Re: Juan Tabo Hills Estates-
Revised Sheet 61R
Hydrology File-M21D018; DRB 1005278; CPN 654887

SUMP INLET CALCULATIONS
For
Cattle Guard Grate at Blue Ribbon Road
(Juan Tabo Hills Estates, CPN 654887)

TITLE: JUAN TABO HILLS ESTATES
HUBBARD STREET S.E. & OFFSITE BLUE RIBBON
UTILITY PLAN & PROFILE

CITY PROJECT NO.	ZONE MAP NO.	SHEET OF
654887	M-21	61R 77

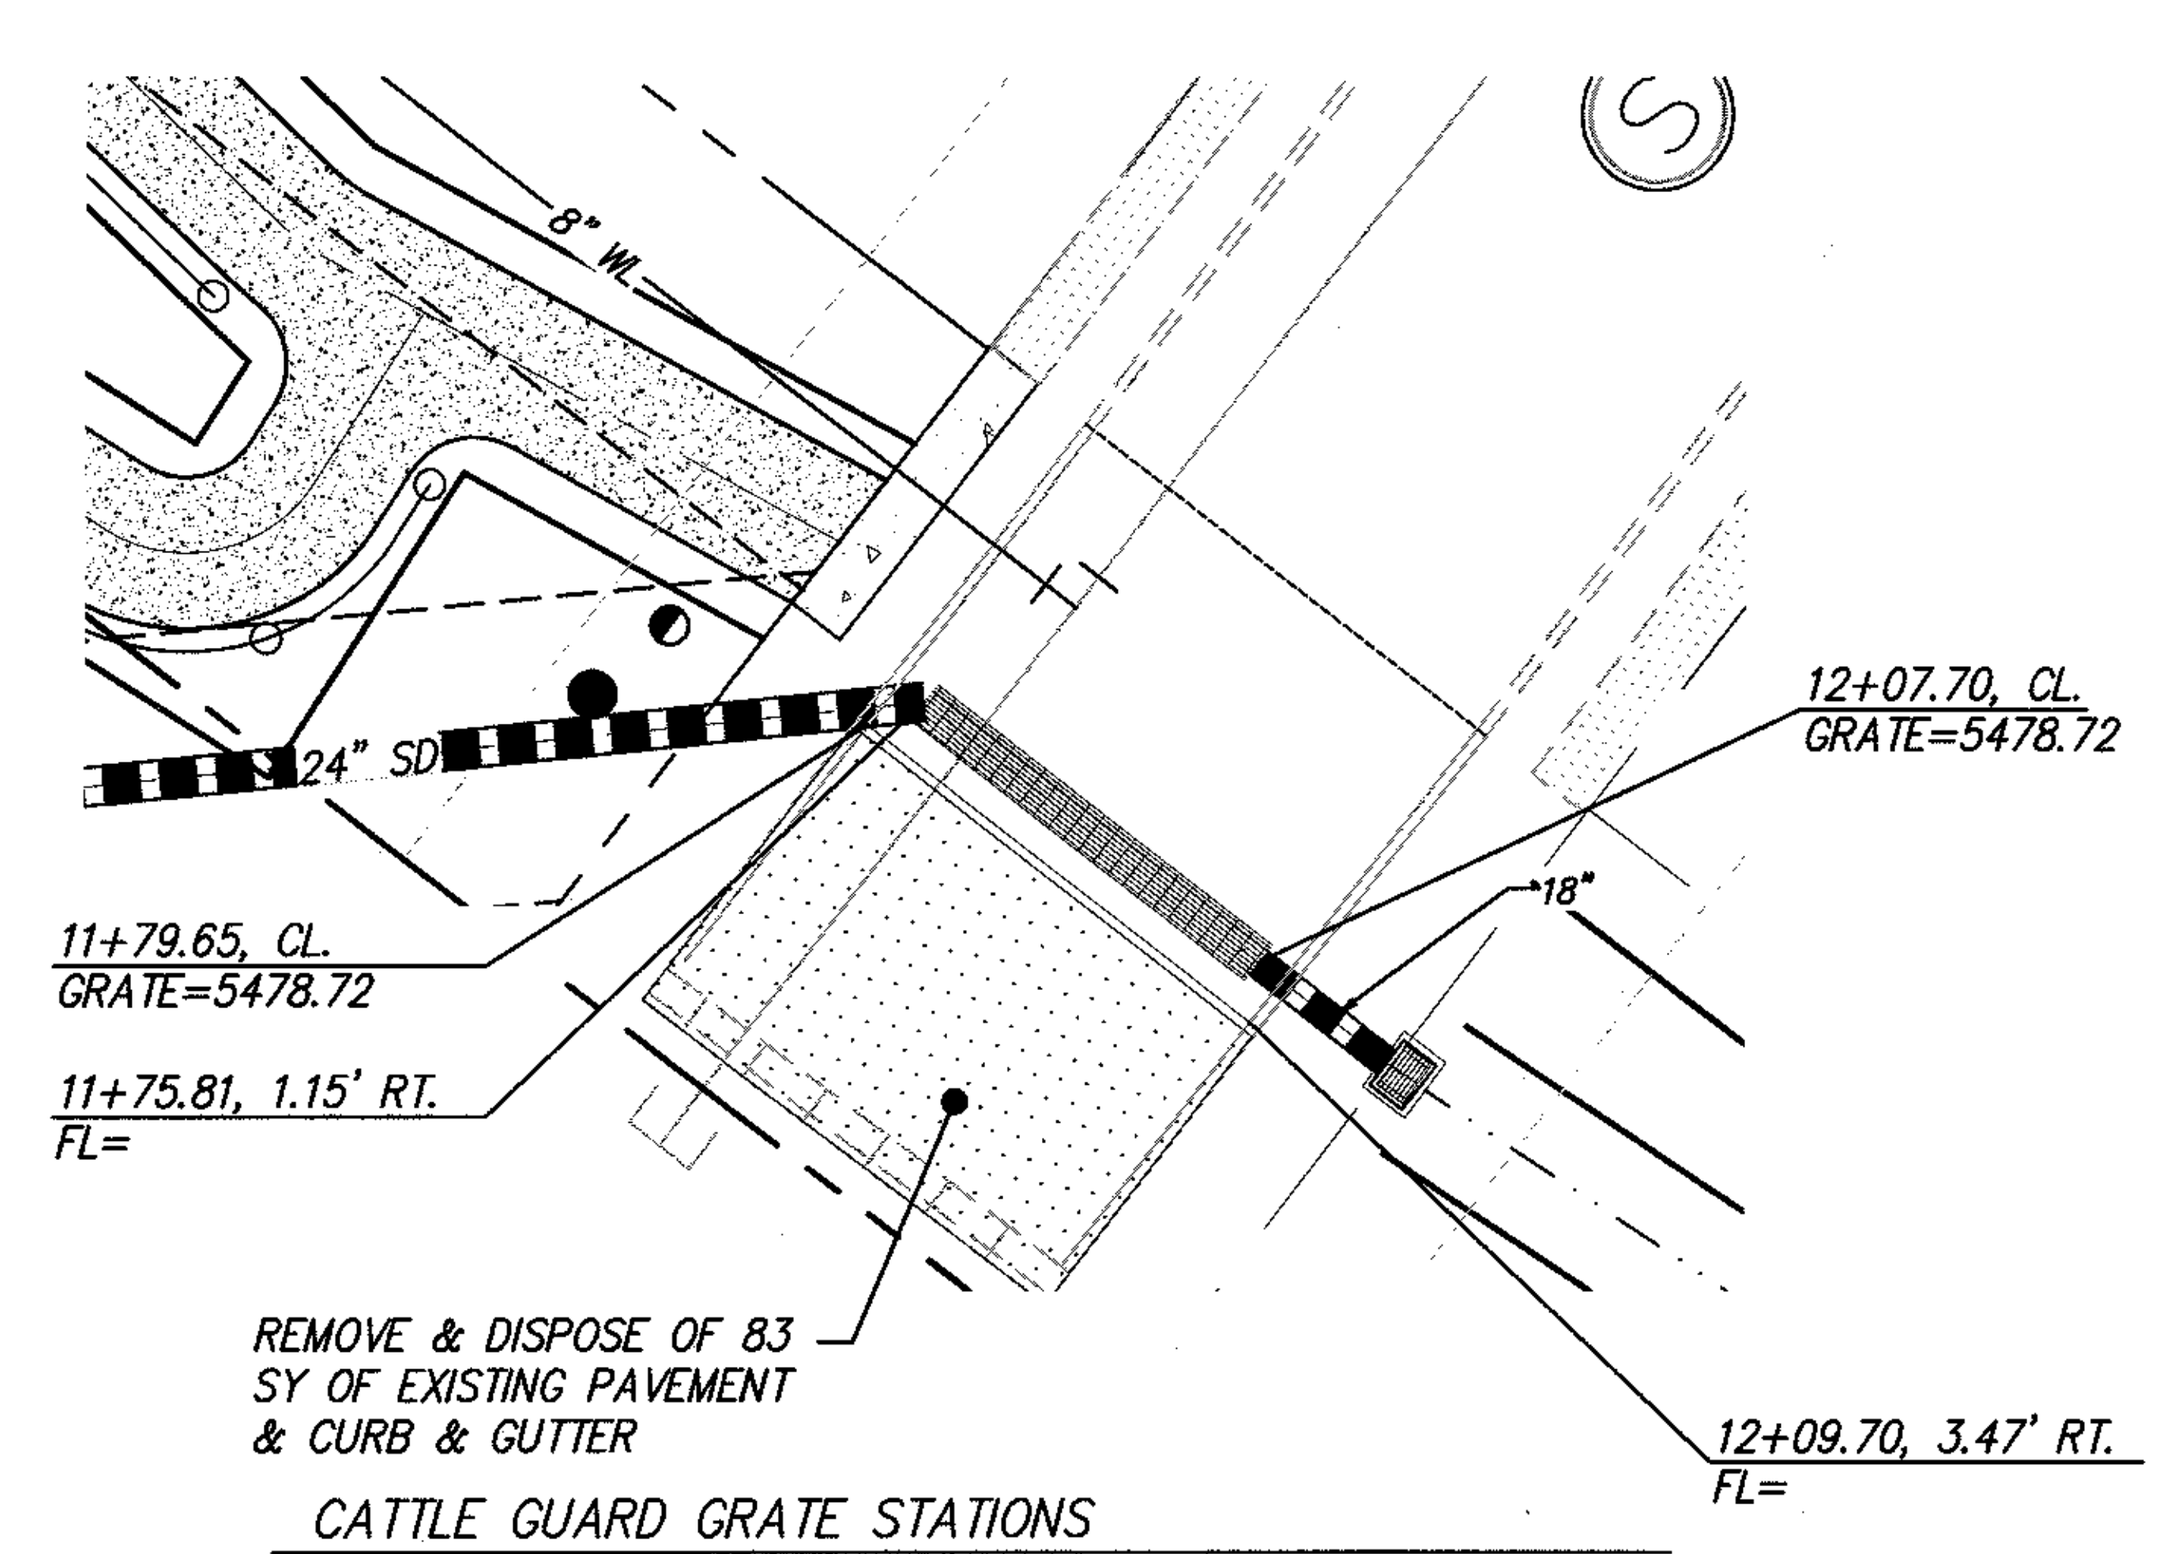
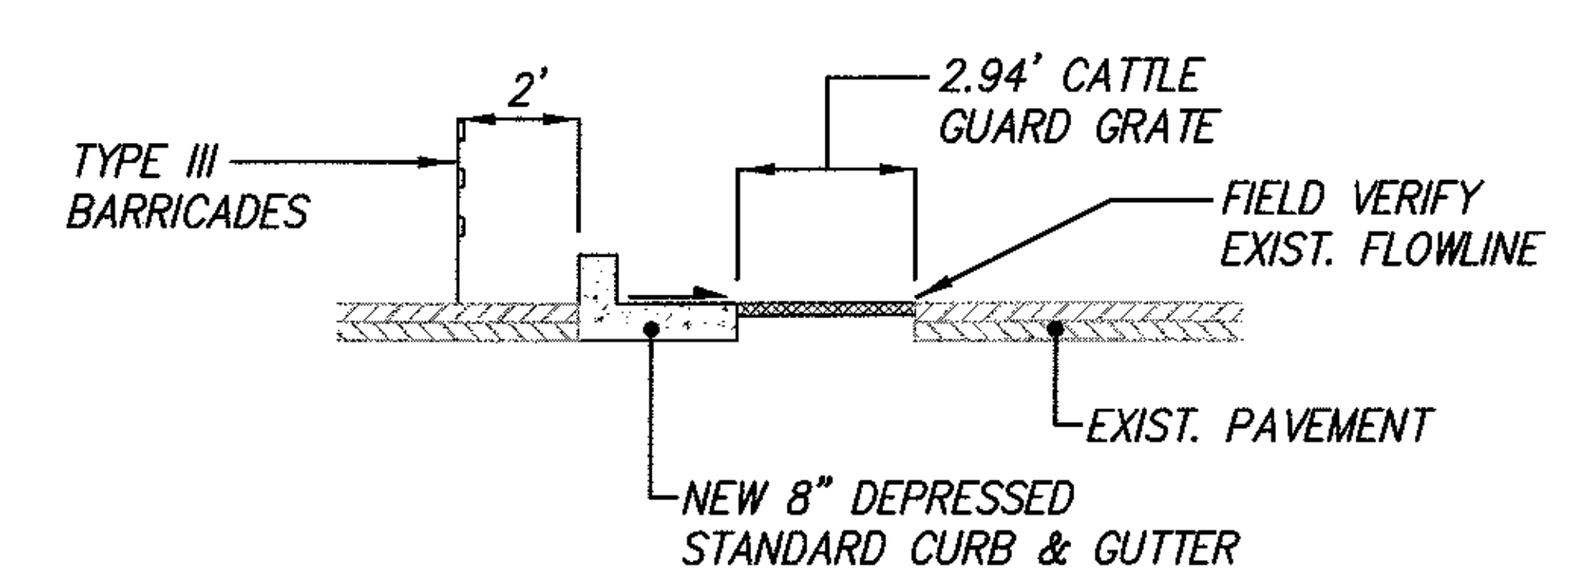
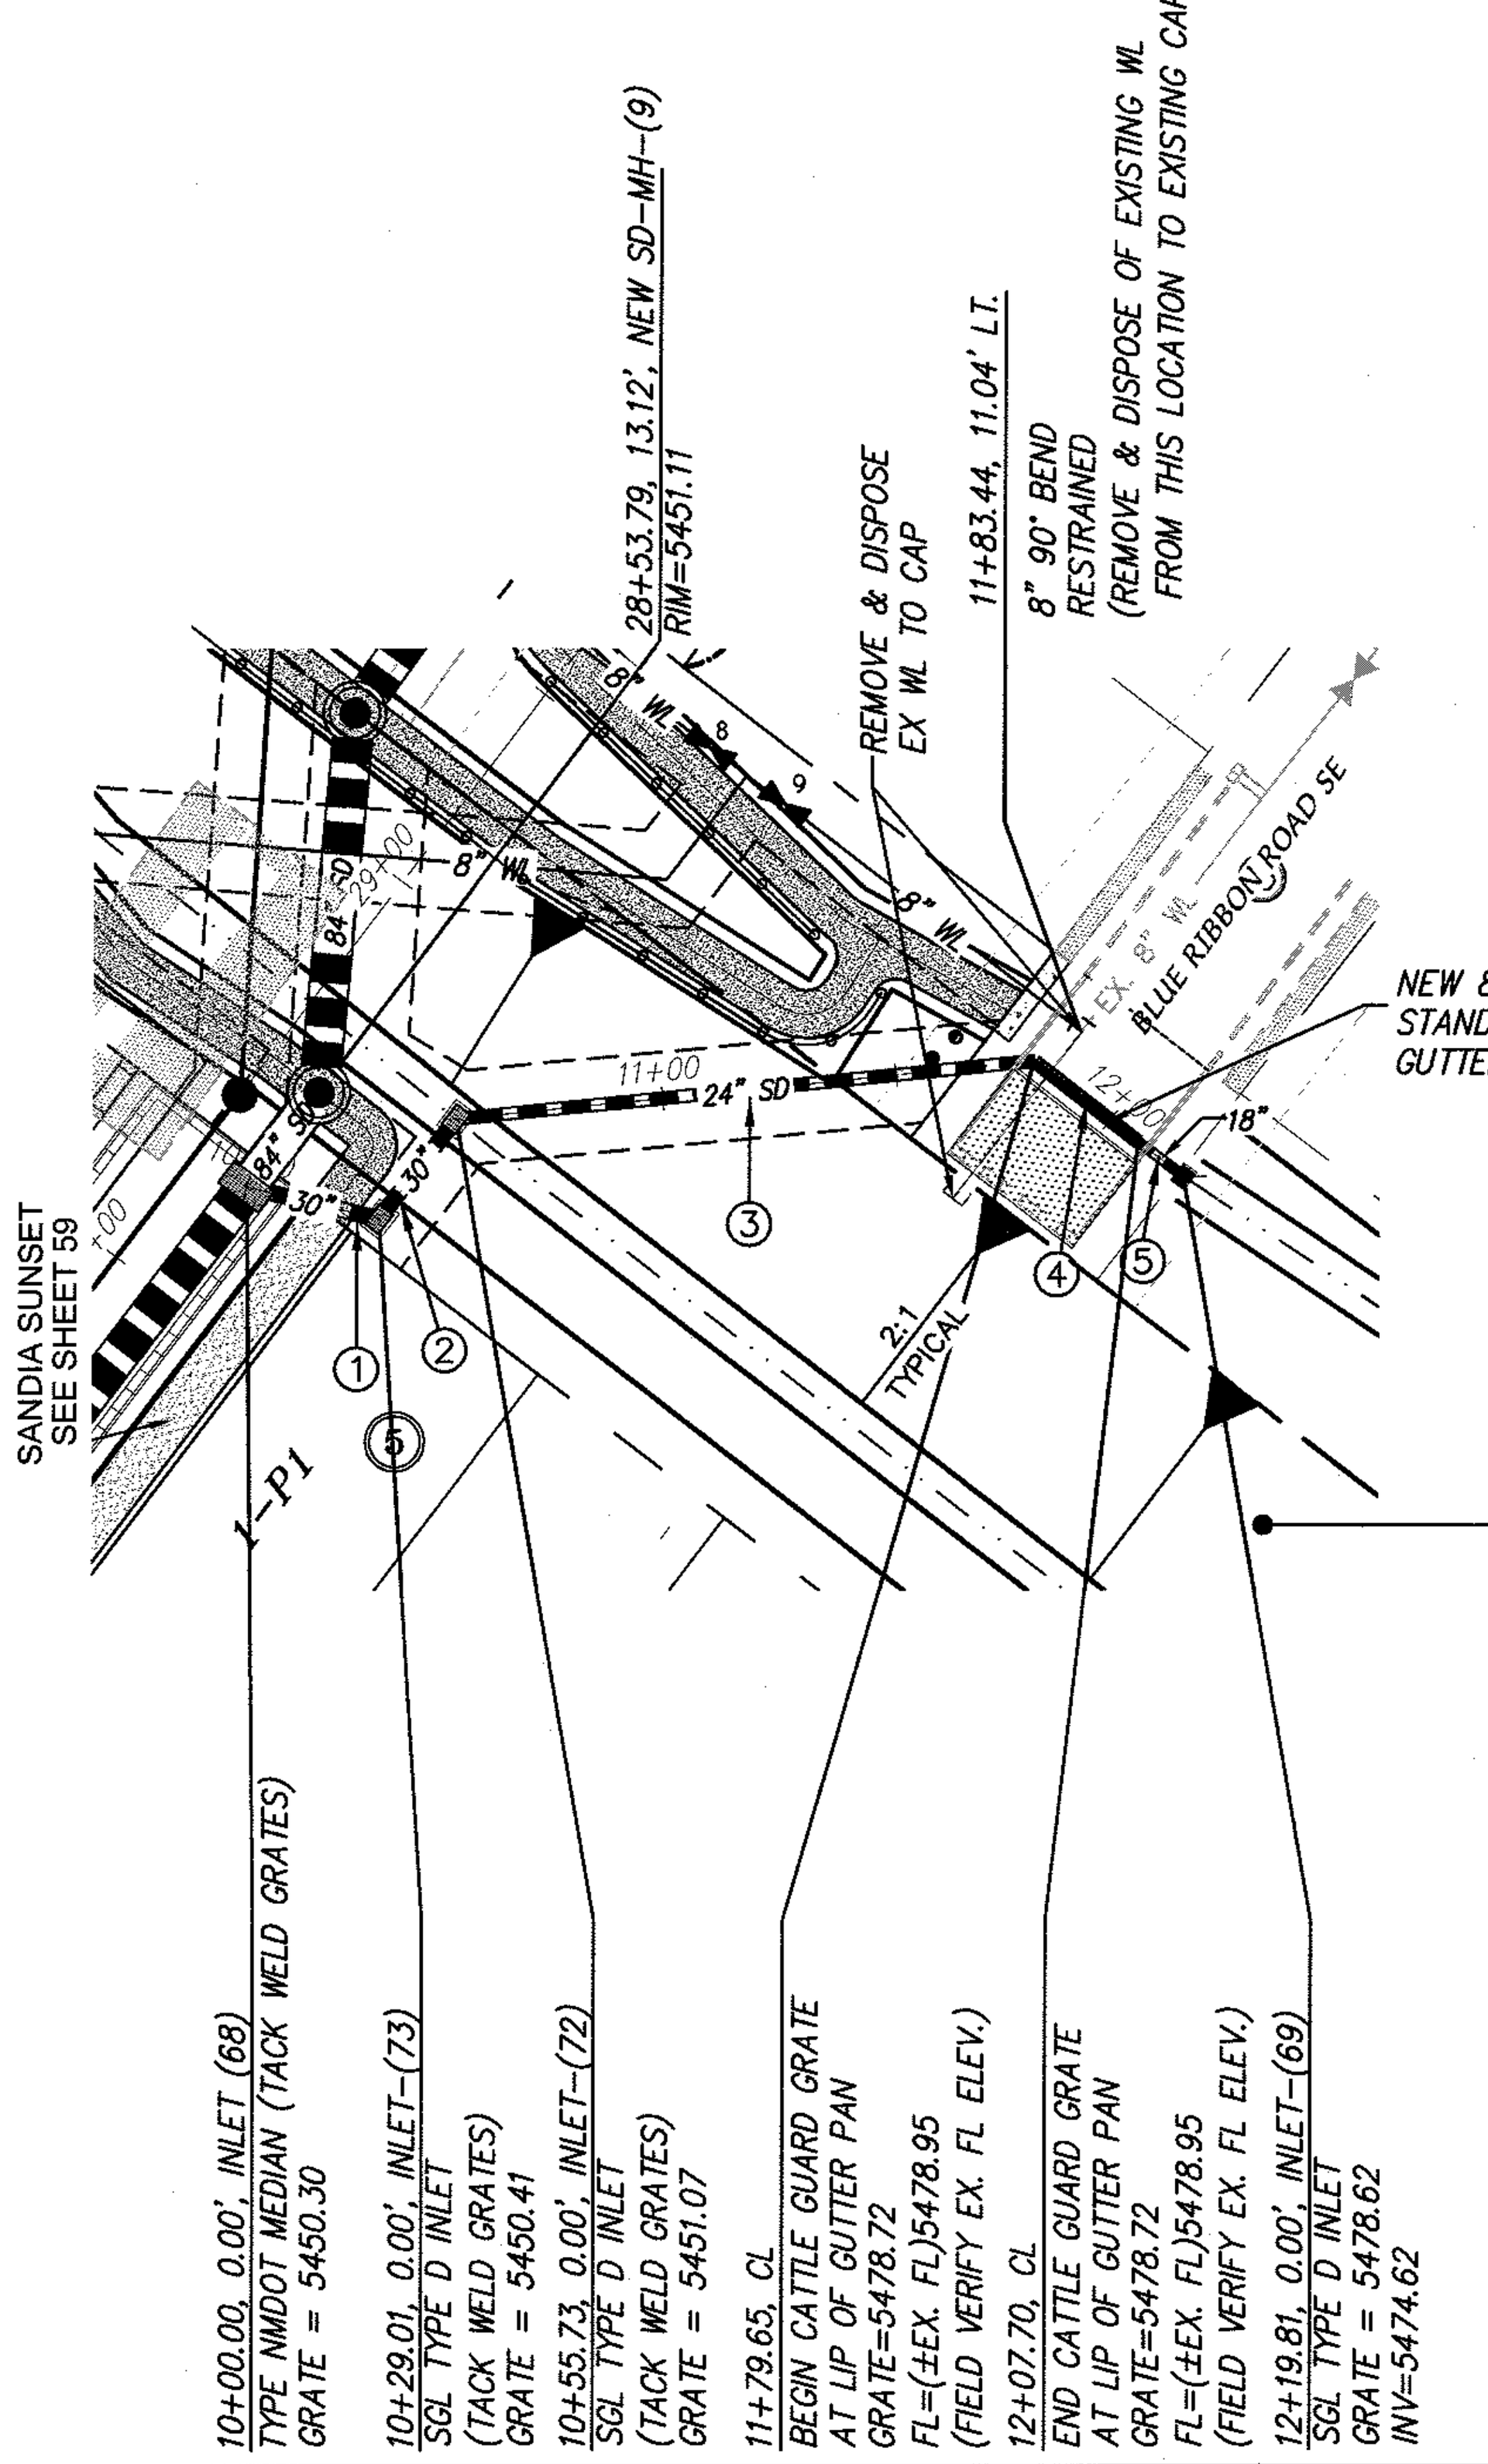
- The revision from two double-A inlets two double-D inlets needs to be supported with calculations demonstrating 2x 100-yr capacity for inlets in a sump using both the orifice and weir calculations.
- The change in inlet type should be noted in the change order request.
- Please put the HGL on the profile on sheet 61R.
- Please note that Easement R will need to be updated on the Final Plat to reflect the new storm drain alignment.

1. The double D inlets have been revised to a cattle guard grate that spans the roadway width. Only the weir equation calculation is necessary for this situation. The weir has almost 2 times the 100 year storm capacity, which should be adequate.
2. Okay.
3. Okay,
4. The final plat has already been revised.

BUILD NEW CATTLE GUARD INLET PER COA STD. DTLS. 2271 AND 2272 WITH FOLLOWING MODIFICATIONS:

1. NO CROWN IN GRATE.
2. DEPRESSED CURB & GUTTER ALONG WEST SIDE OF CATTLE GUARD INLET.
3. CONNECT 18" RCP AT SOUTH END.
4. CONNECT NW END TO 24" RCP.
5. CATTLE GUARD INVERT SLOPE = 1.0% SOUTH TO NORTH.
